Posted for Public Notice: May 31, 2023

City of Bend Standards and Specification Summary of 2023 Revisions

Standards and Specifications 2023 Update

DRAWN AJD	
DIV ROADWAY	
REV	DATE

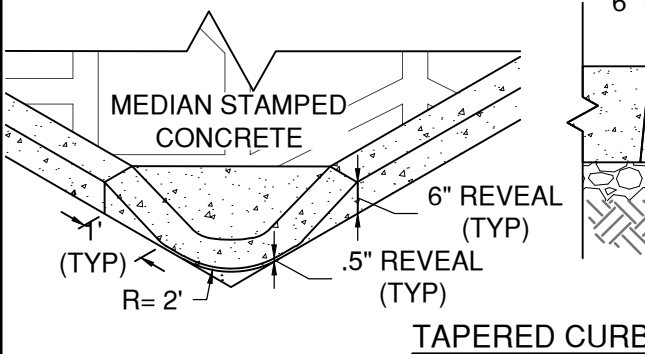
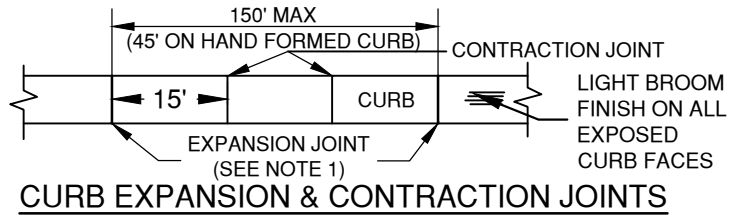
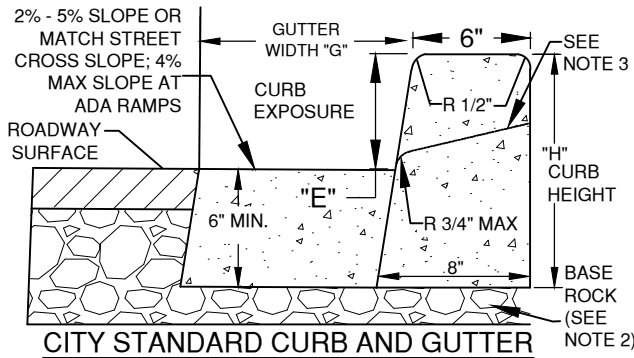
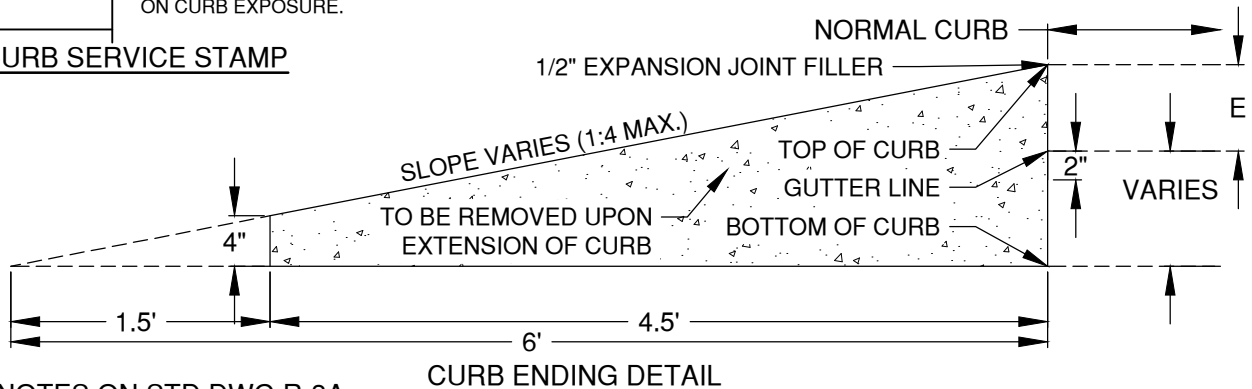
REMOVED
STANDARD
CURB WITH
WEEP
HOLE
DETAIL

**RECTANGULAR RAPID FLASHING BEACON SYSTEM
PSST INSTALLATION**

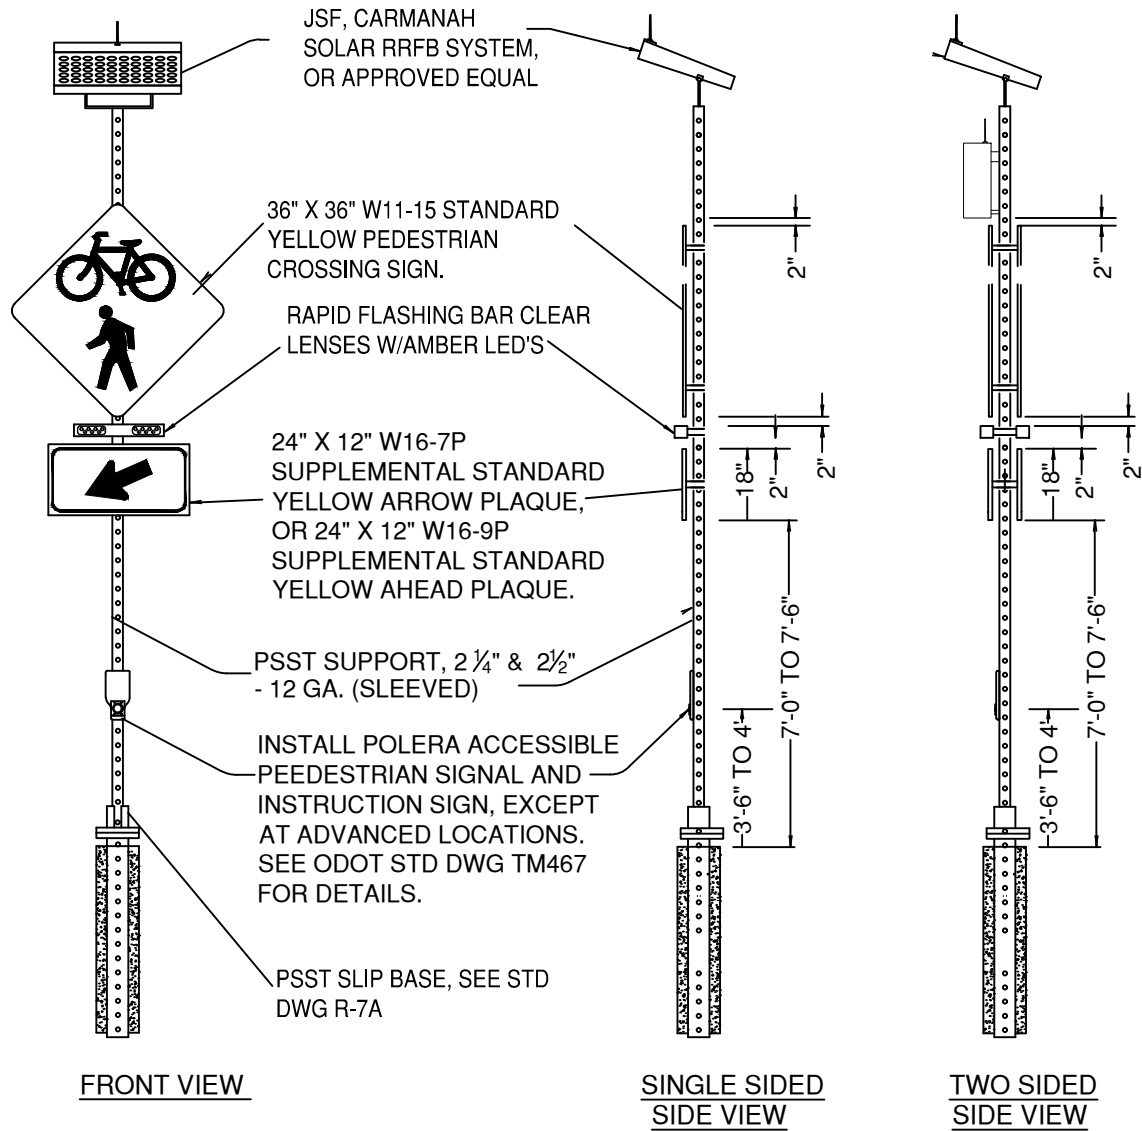
REPLACED "ADD RADIO NETWORK CONTROLLER FOR WIRELESS EQUIPMENT IF NEEDED"

STANDARD PRE-CAST DRYWELL

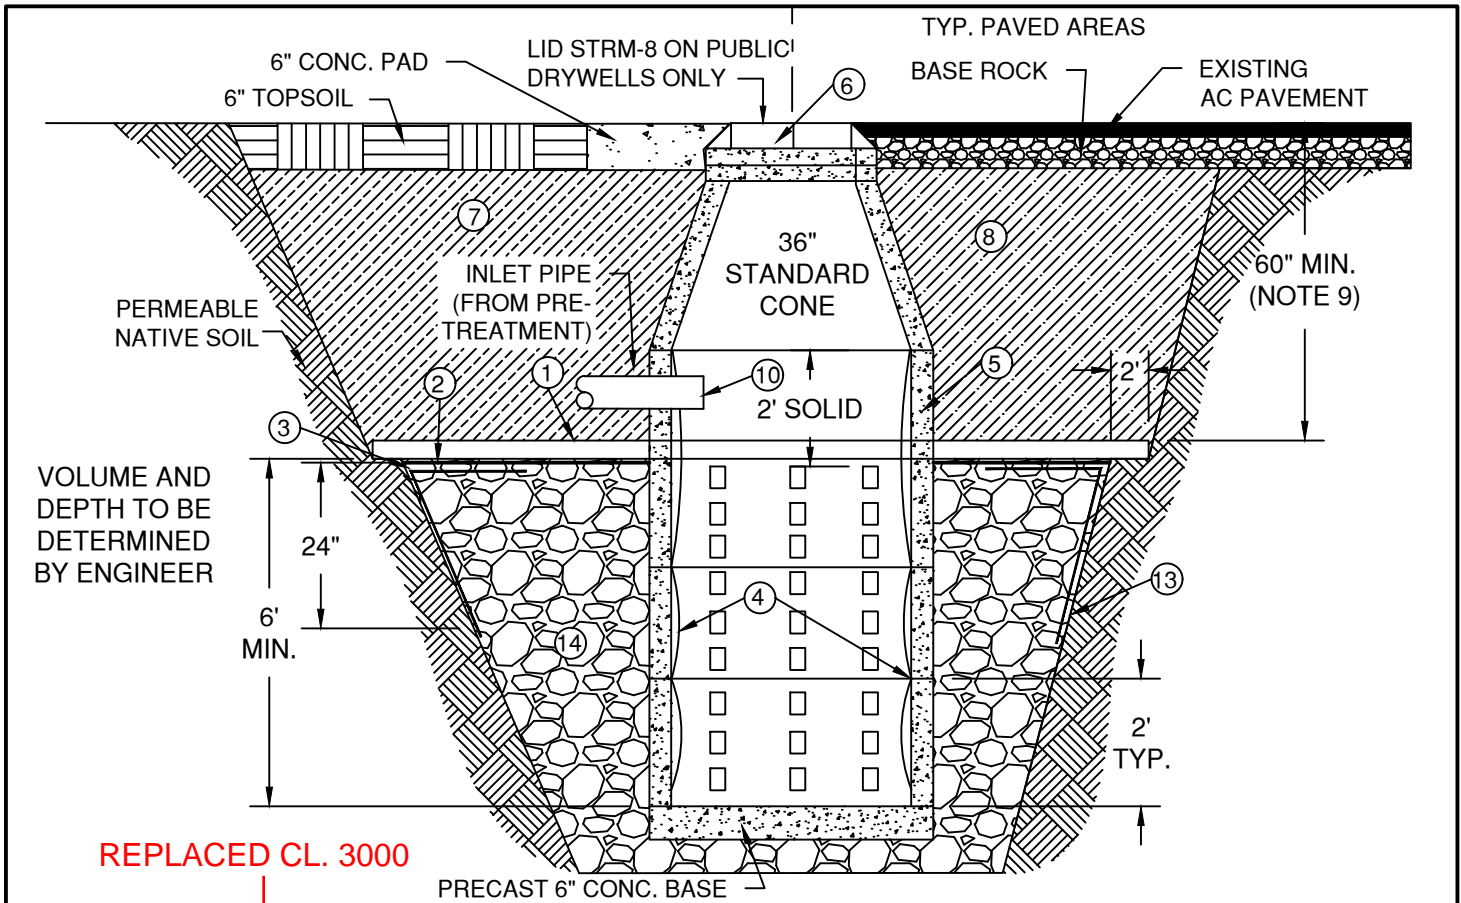
REPLACED CL. 3000

DRAWN AJD		CITY OF BEND STANDARD DRAWING 710 NW WALL ST., BEND, OREGON 97701	SCALE NTS
DIV STORM			DATE 03/22/2023
REV	DATE		APPR
		STANDARD CATCH BASIN	STD DWG STRM-12

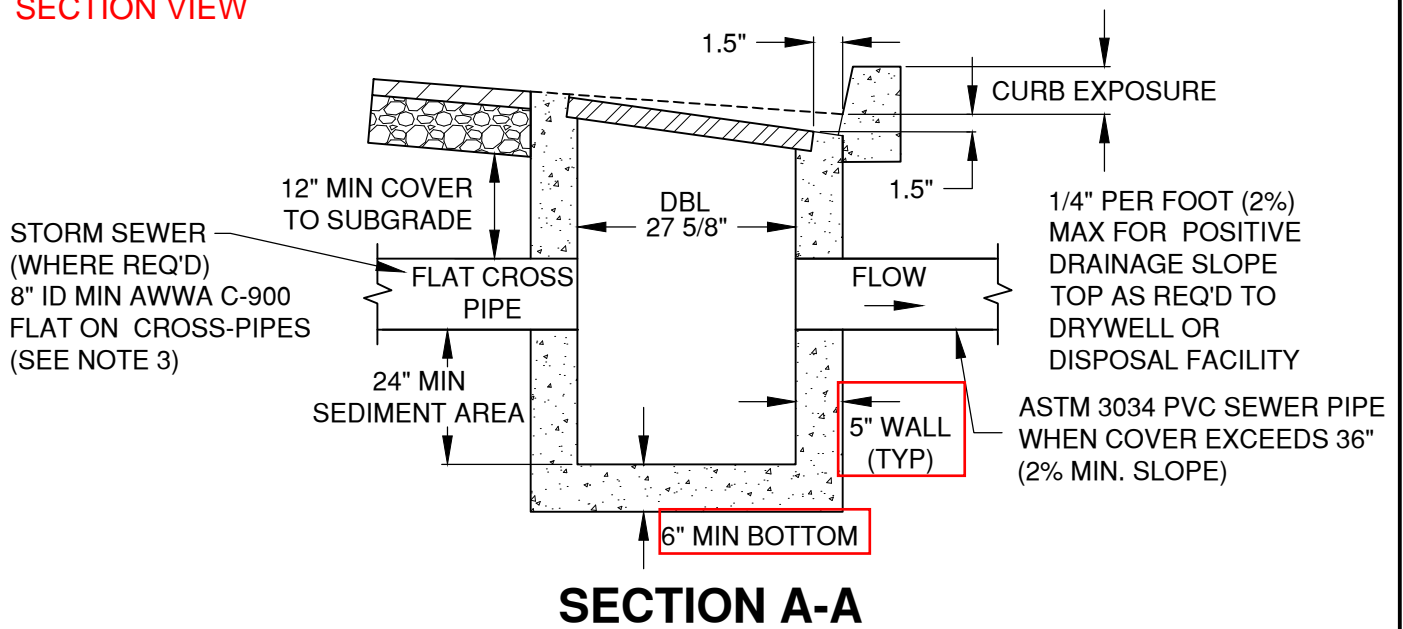
PLAN VIEW MOVED
TO ABOVE
SECTION VIEW

TEXT MODIFIED
